Re: Application by Greenhouse Road Landfill, L.P. for a Major Amendment to
MSW Permit 1599A; TCEQ Docket No. 2019-1534-MSW

**GARY D BROWN’S RESPONSE TO SOAH HEARING REQUESTS
AND RESPONSE TO MOTION REQUESTS FOR RECONSIDERATION**

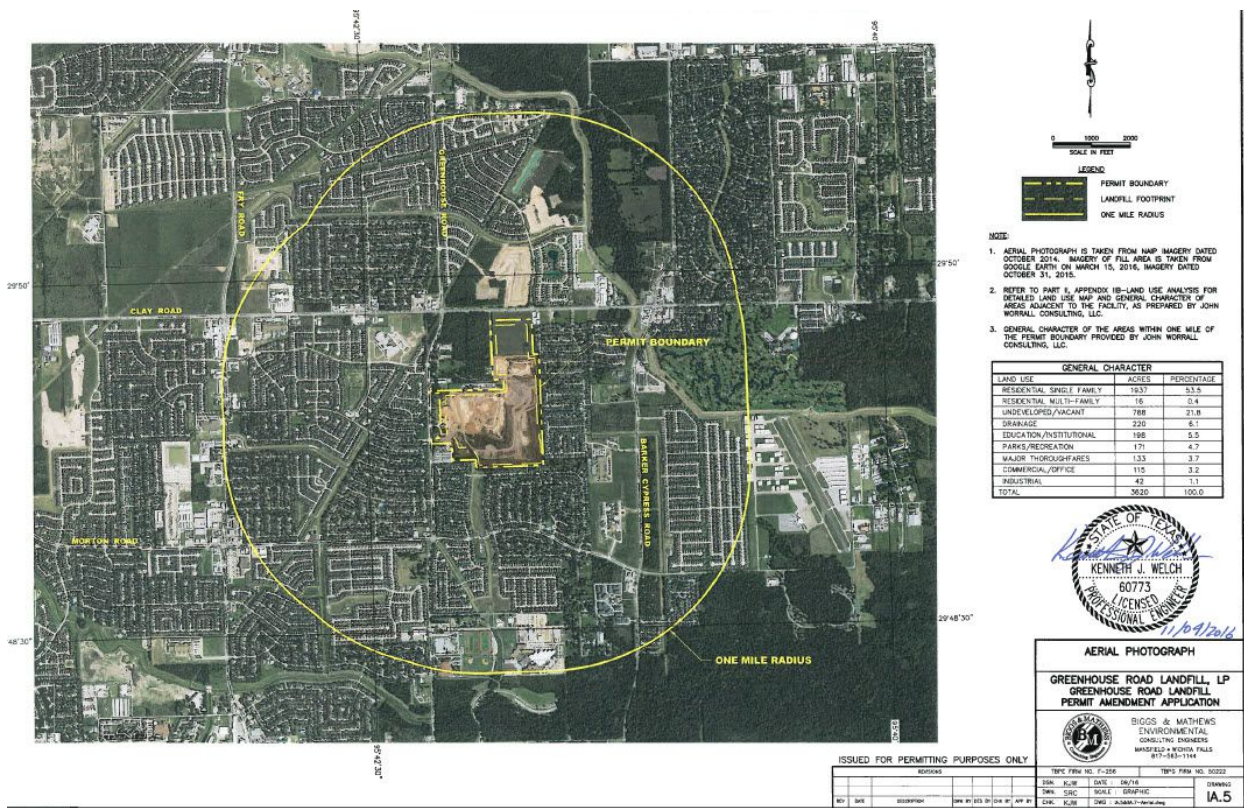
The following submission of current (existing) conditions were approved by TCEQ. They are factually false, as 25 year rainfall events (stormwater) exist which were not diverted to the ditch U101-01 and the southwest detention pond. Rather the water was discharged into subdivisions. This information has been submitted multiple times to TCEQ to include videos, pictures, rainfall gages, and to Harris County Pollution Control Services (hereafter PCSD). See Prints C1-B-5 and C1-B-6 which TCEQ approved and were sealed 11/4/2016.

Design prints not constructed do not satisfy 30 TAC §330.303a or 30 TAC §330.373d.

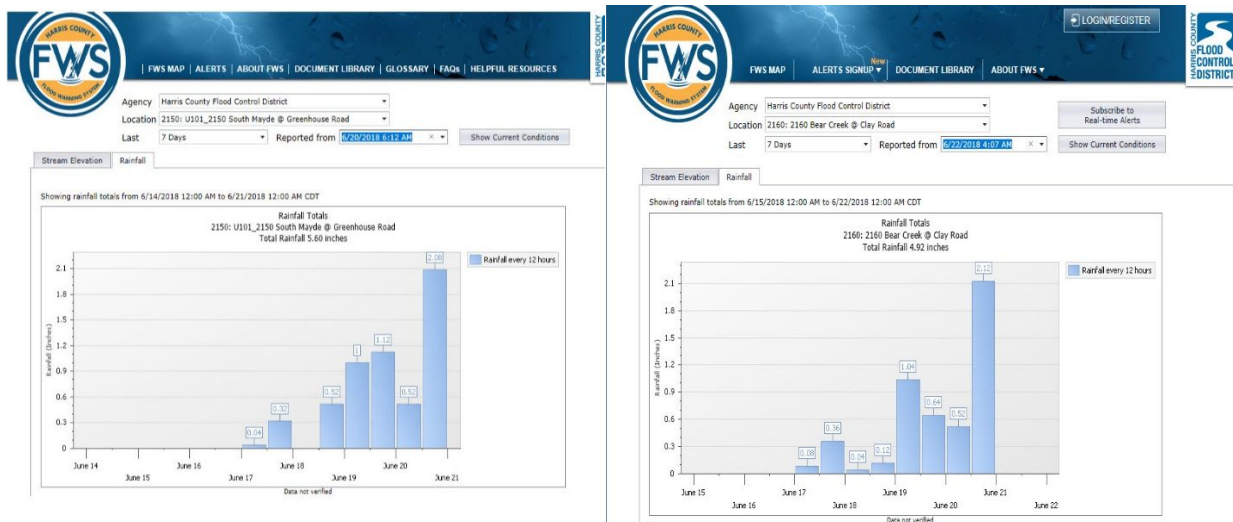
The following Harris County Flood Warning rain gages (2150 & 2160) were used to determine the rainfall amounts, dates, and rates by the Harris County Flood Control District, as the gages are one mile or within one mile of the Greenhouse Road Landfill. An example would be the 3.84 inch rain fall which flooded Shadow Trail Lane ending on September 23, 2018.

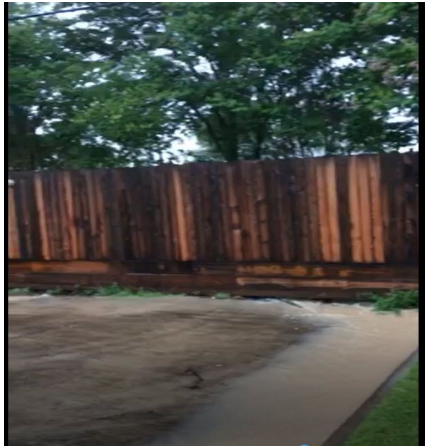
This 5" rainfall produced the following flooding into Barker Ridge on Log Trail Lane.

Ponding for 30 days behind lot 292 in Rolling Green occurred in December 2018 with rainfall less than 9", the 25 year rainfall event standard. 12/8/18 rain gage 2150 was 5 inches. 12/27/18 rain gage was 2.8 inches. 1/3/20 rain gage was 2 inches. Note the Green Landfill fence.

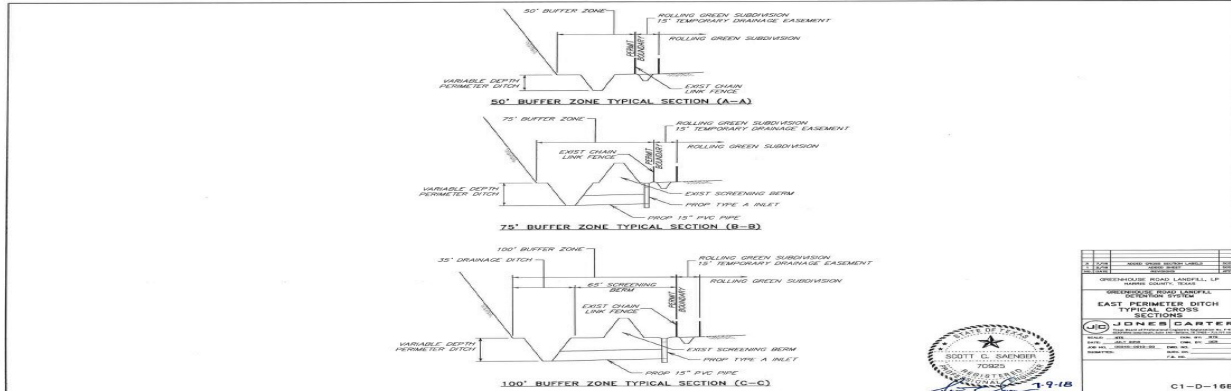
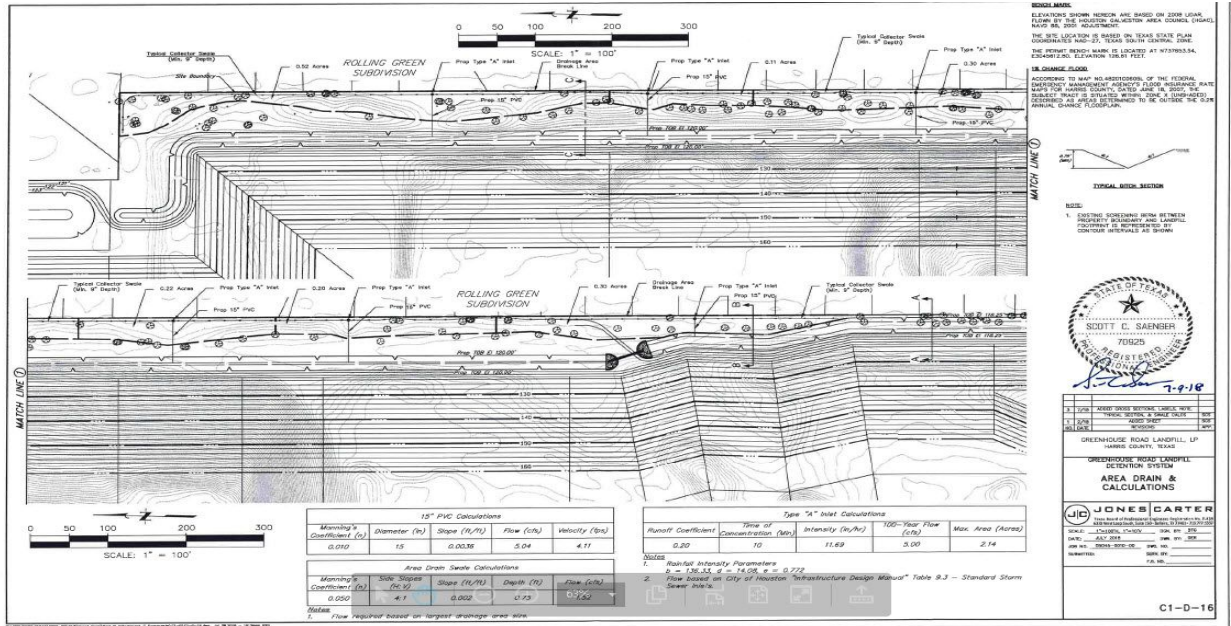
The landfill operator incorrectly stated all 1599A permit modifications “were made.” The landfill operator owns only his one-half of the border easement. After 17 years, the landfill operator has submitted in his 1599B application modifications to design, construct, and manager stormwater drainage on the east boundary to discharge to the SW detention pond per the 1599A Saitas modification. Attached are design drawings were submitted on 7/9/18, C1-D-16 and C1-D-16B.

This is an admission that in order to comply with 30 TAC §330.303a and 30 TAC §330.373d, and this modification must be implemented now. It has not been. The Landfill operator has stated within 180 days of permit 1599B approval in this application, he will construct this design. He has also stated that if 1599B is not approved, he will not construct this required modification per 3/28/19 TCEQ public meeting voice recording. A modification was submitted and approved for landfill gas during the 1599B application period submission. Why did he not include these drainage modifications? Note also in C1-D-16B, the easement is incorrectly shown on the Rolling Green subdivision side only. Further, it is designed to drain water uphill, with no clean out access and check valve. If the landfill is capable of handling a 100 year rainfall flooding event, why is not capable of handling a 5 inch and lower rainfall events?

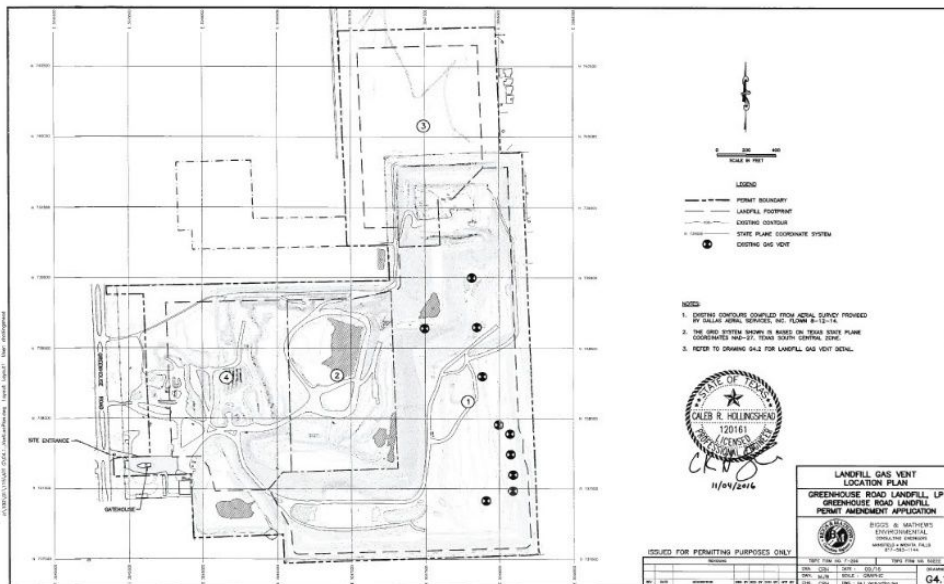
Landfill gases, both Methane and Hydrogen Sulfide gas (H2S) are being generated by the Greenhouse road landfill and being emitted. The odor control management system does not properly address and control the emissions; being inadequate. Testing quarterly methane wells does not provide immediate ability to notify local officials timely for an evacuation. In complaints submitted to Pollution Control Services Davison (PCSD)), actual measure of PPM of hydrogen sulfide gas are not taken. Schools are within one mile of the landfill, with Schmaltz elementary, the closest within 1000 feet. PCSD has detected (H2S) in inspections of the site. Print G4.1 shows the location of the passive PCV pipe/Turbovent monitor LPG vents. Print G1.1 shows the location of the LPG methane wells, and Print G1.2 shows structures within a quarter mile of the landfill.
